**PORTAGE COUNTY
EMERGENCY OPERATIONS CENTER**

HAI Project No. 22048.001

To: All Bidders

This Addendum becomes a part of the Contract Documents and modifies the original Bidding Documents dated 4-25-2023, as noted below. The Bidder shall acknowledge receipt of this Addendum on the Form of Proposal. Failure to do so may subject the Bidder to disqualification.

4 SANITARY ISOMETRIC
P3-1

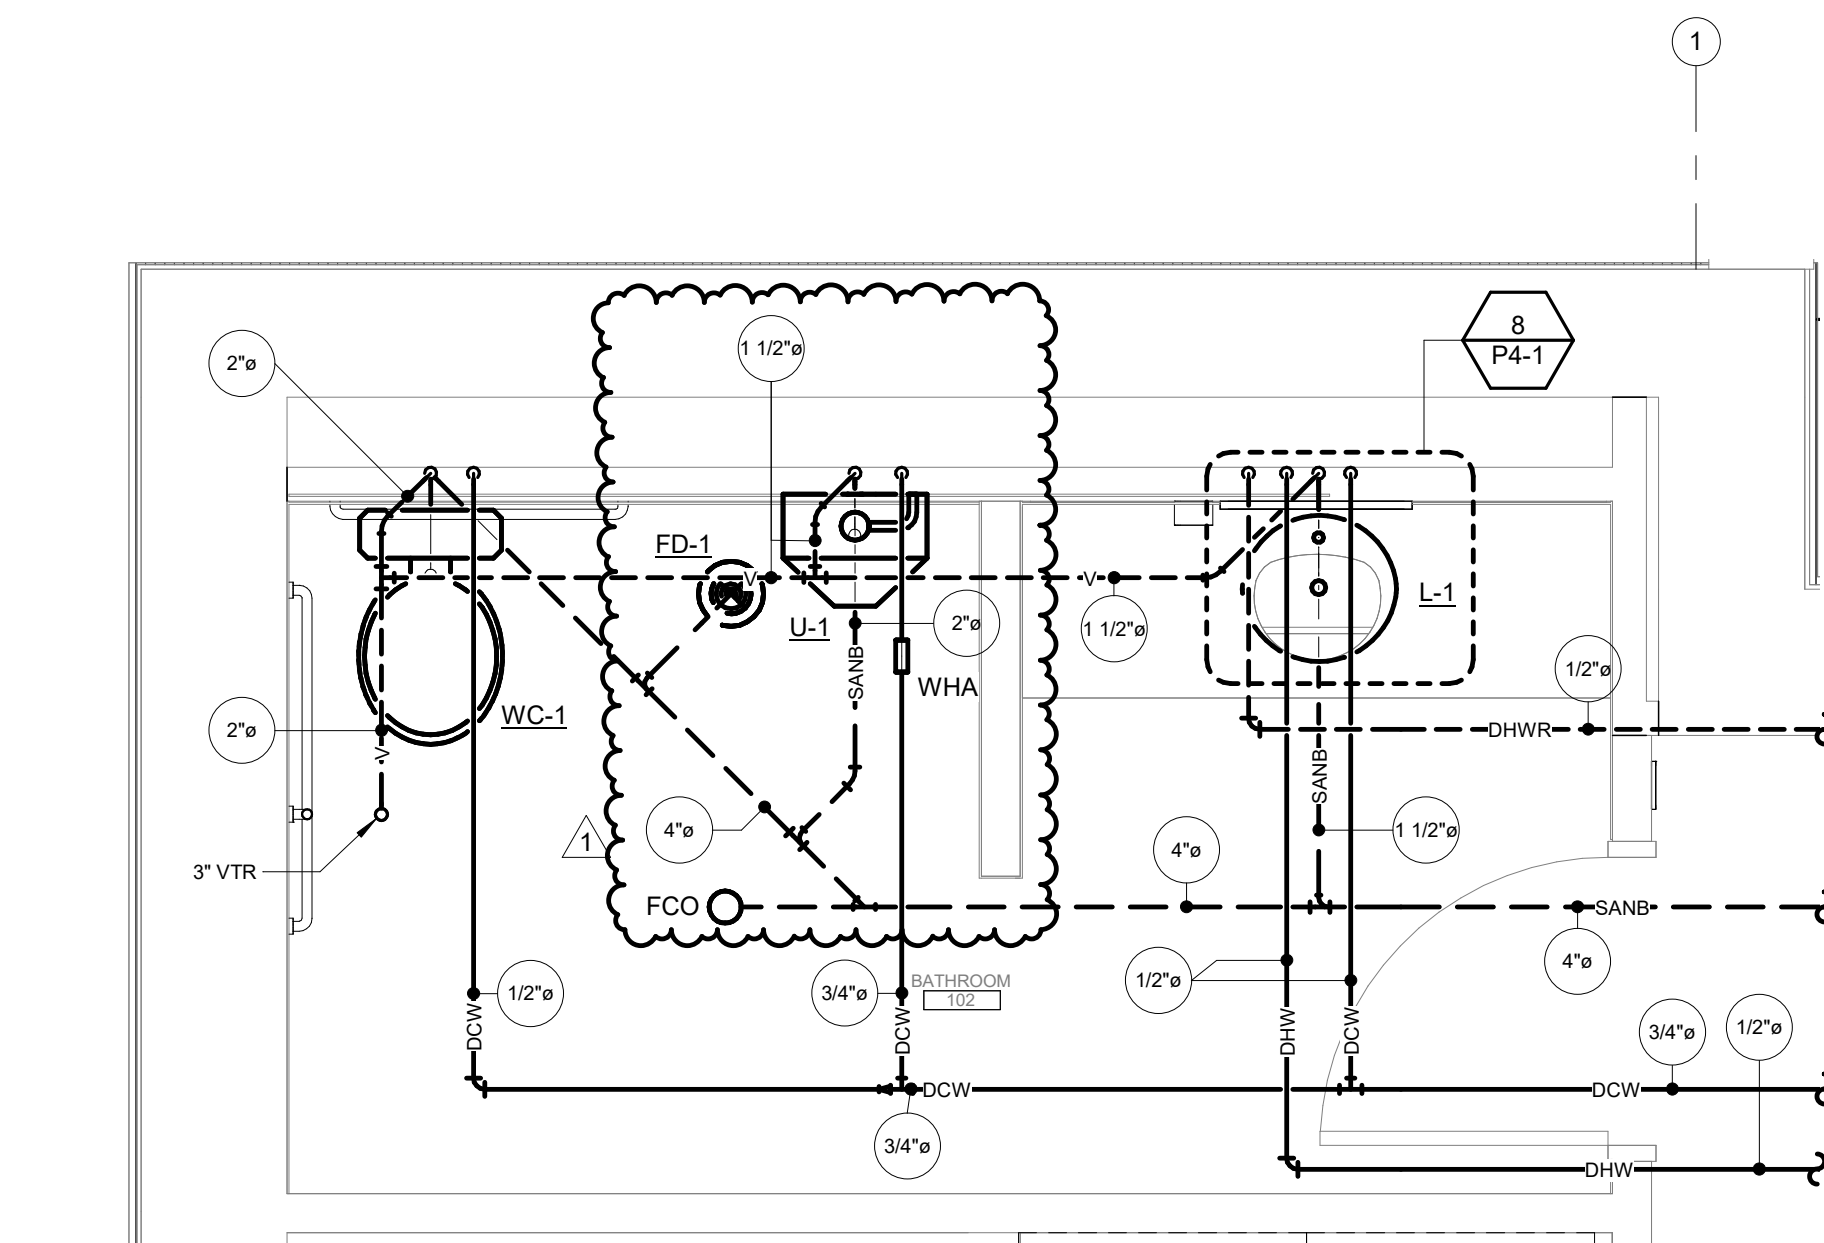
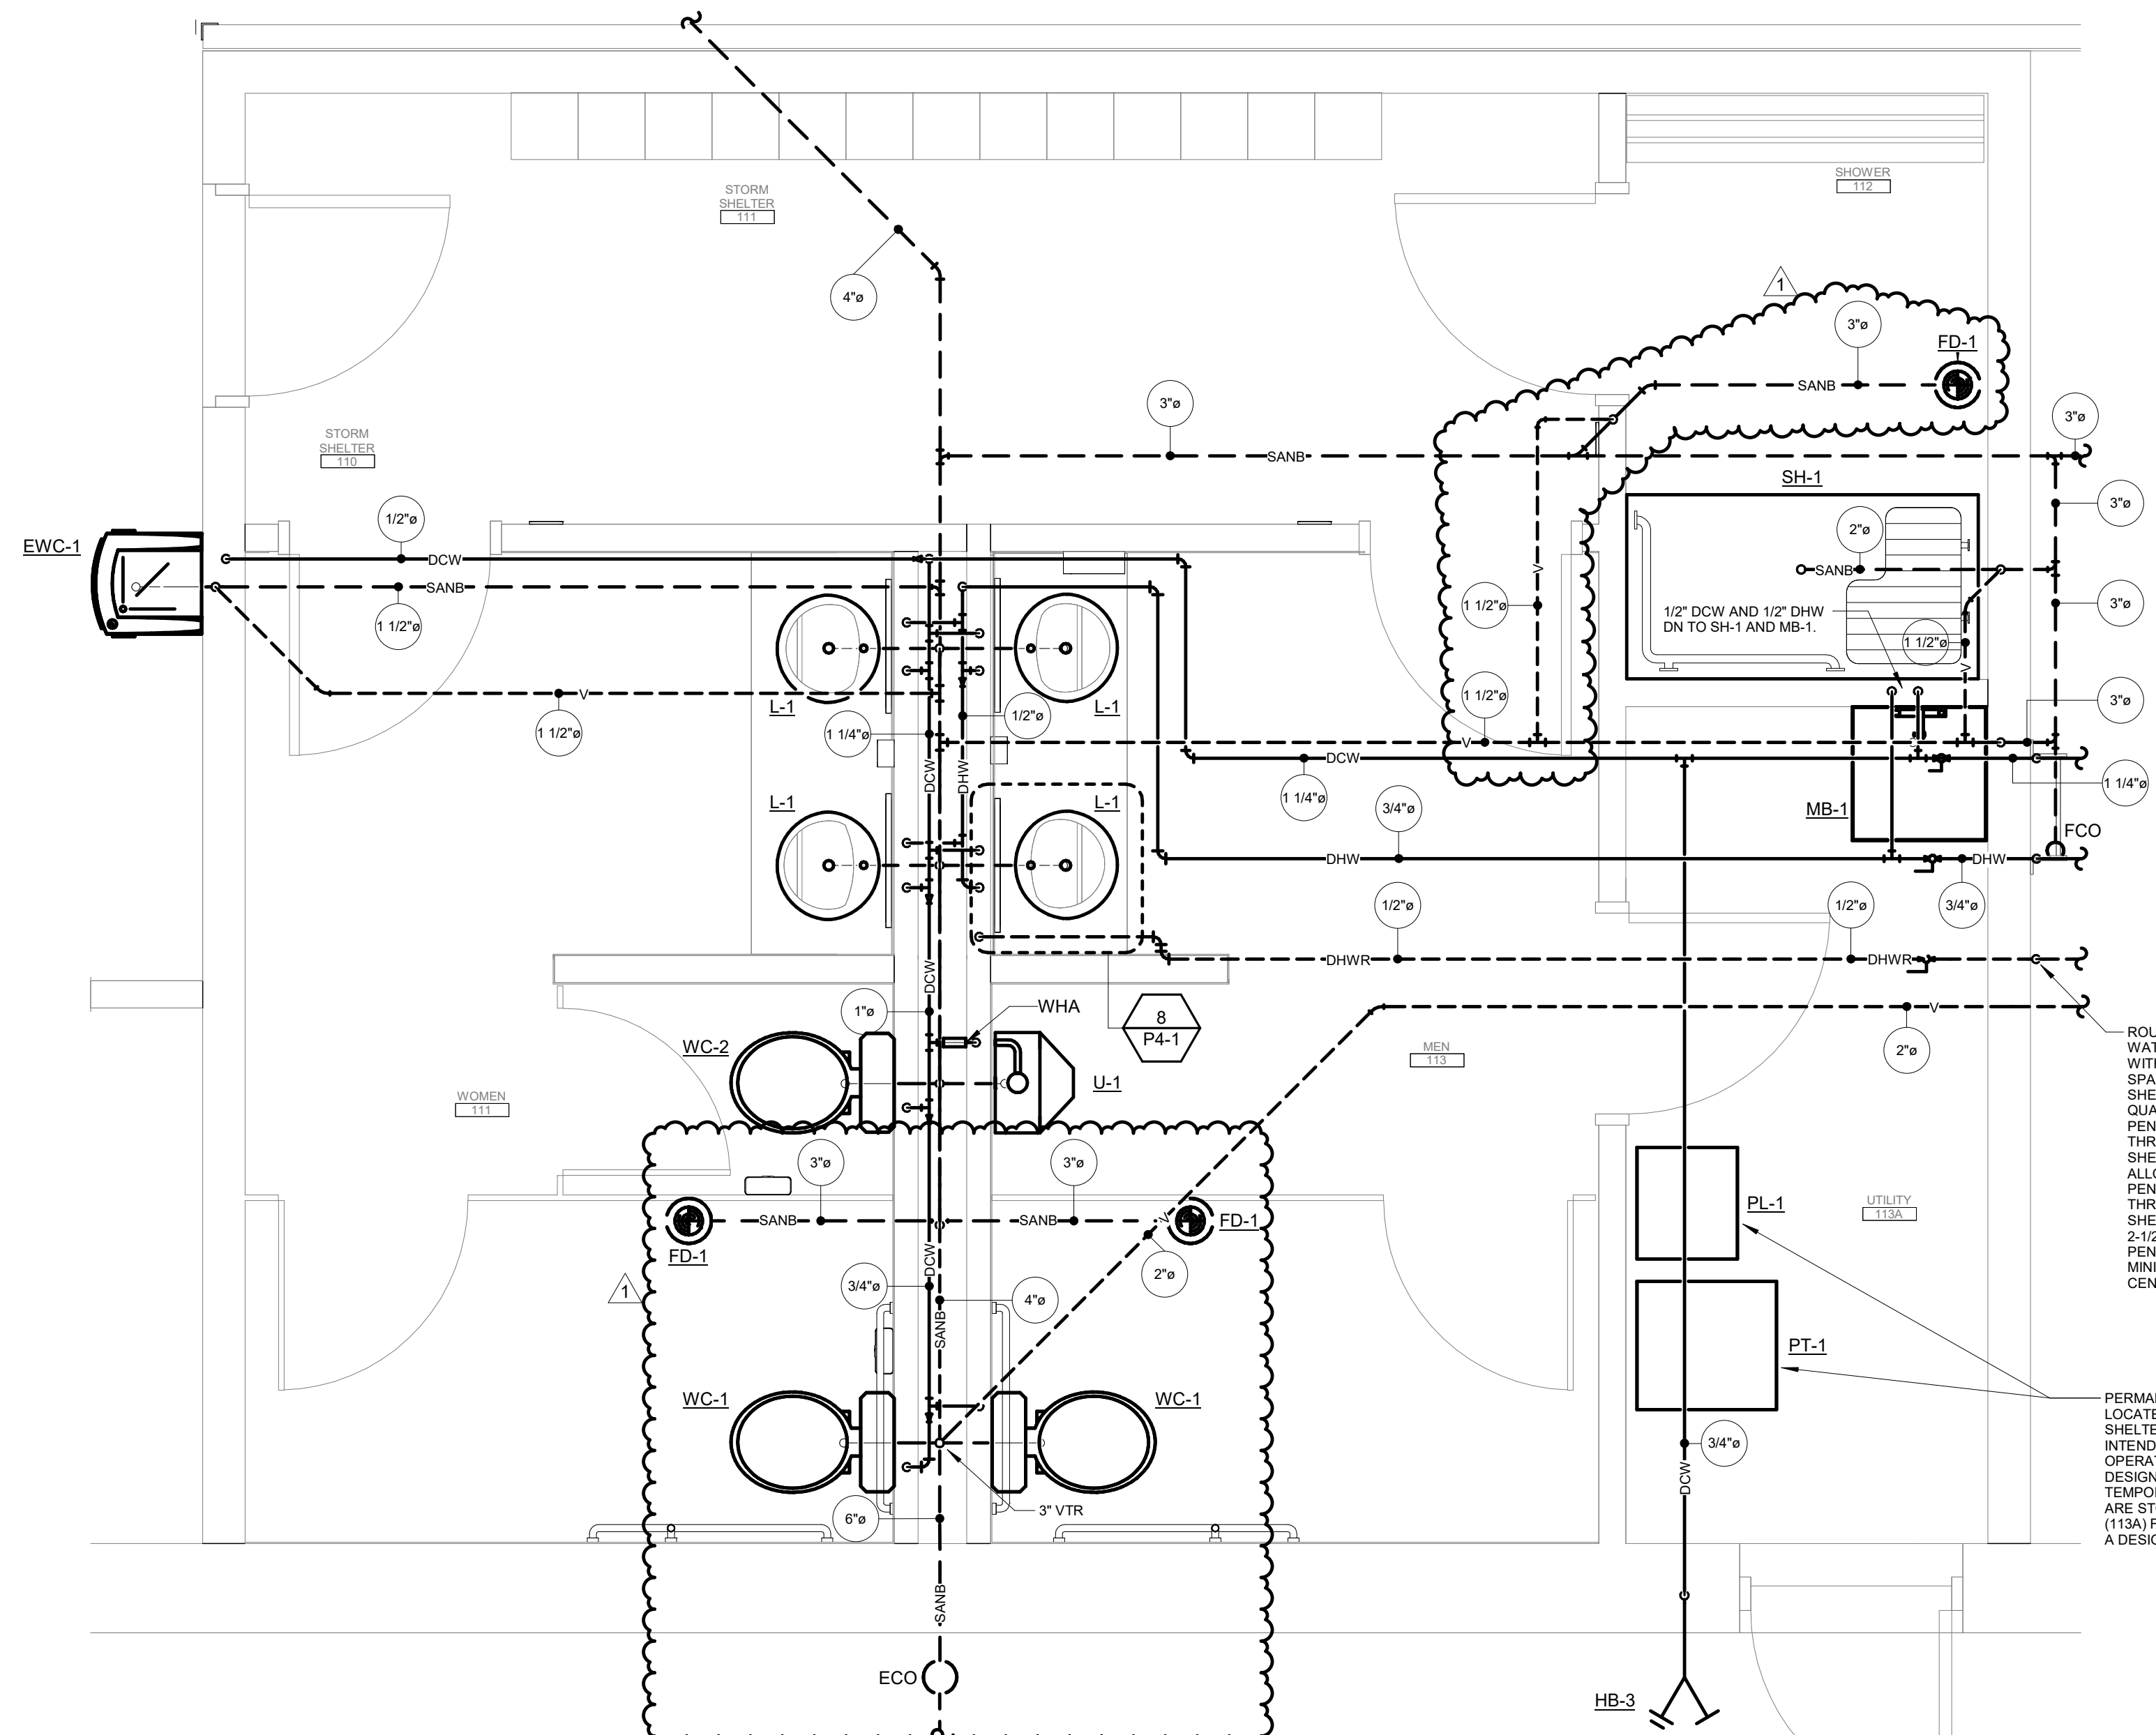
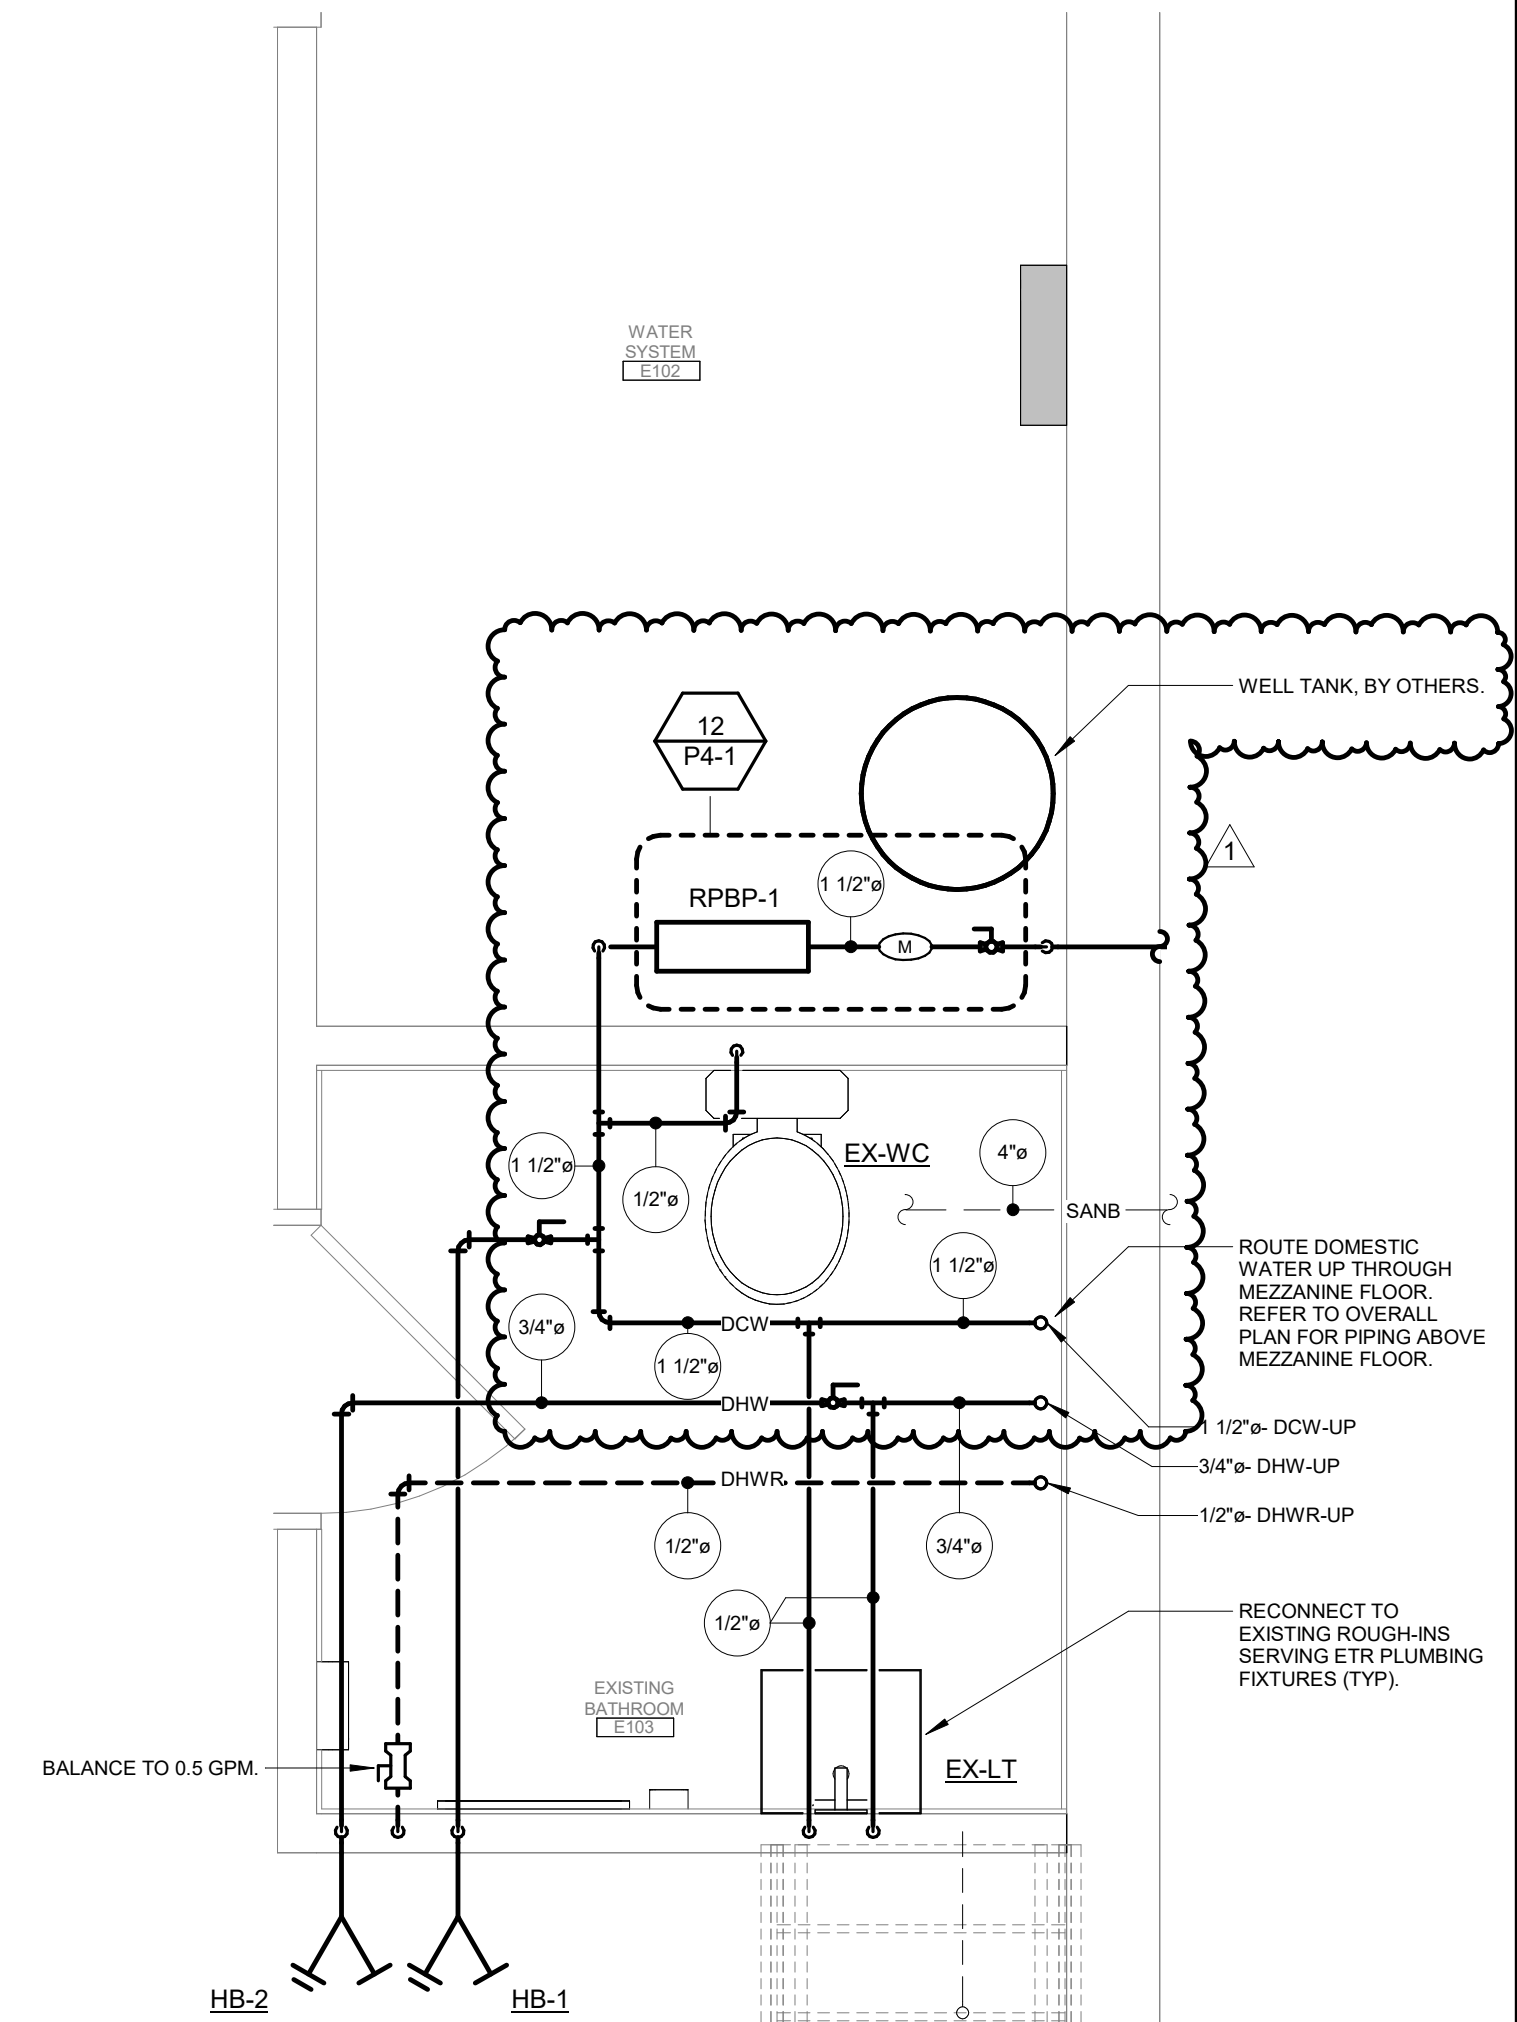
4. REVISED TO INCLUDE VENT LINE FROM EXTERIOR GREASE INTERCEPTOR.
- c. P3-1 ENLARGED PLUMBING PLANS AND SANITARY ISO
 1. REVISED TO INCLUDE FLOOR DRAINS IN BATHROOM (102), WOMEN (111), SHOWER (112), AND MEN (113).

2. REVISED TO INCLUDE WATER METER AND REDUCED PRESSURE BACKFLOW PREVENTER AT WATER ENTRY.
- d. P4-1 PLUMBING SCHEDULE AND DETAILS:
 1. REVISED TO INCLUDE WATER ENTRY SCHEDULE, DETAIL AND GENERAL NOTES.
